Office Action Summary	Application No. 10/823,777	Applicant(s) KOLESNYCHENKO ET AL.	
	Examiner Kevin Gutierrez	Art Unit 2851

DETAILED ACTION

Provided figure 1

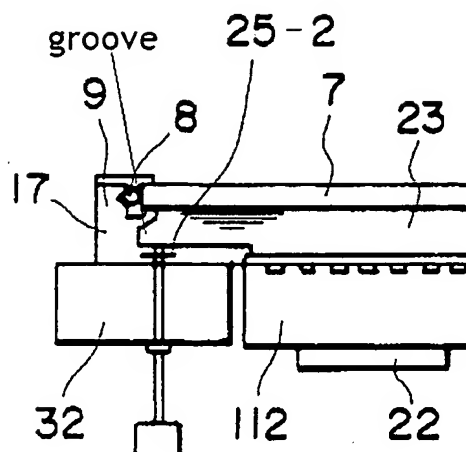
Regarding claims 4 and 21, Takahashi discloses “wherein the barrier (9, 17) comprises a groove (see provided figure 1 below, where groove is indicated) recessed into an upper surface of the substrate table (112).”

Regarding claim 5, Takahashi discloses “wherein the groove is sized such that the liquid (23) can be transported along the groove under capillary action (see fig. 2, where the liquid 23 can be transported and contained within groove showing in provided figure 1 above).”

Regarding claims 12 and 25, Takahashi discloses “wherein the barrier (9, 17) comprises a groove and a projection which projects out of an upper surface of the substrate table (see provided figure 1 above, where the element 17 is projected upwards from the substrate table with a groove).”
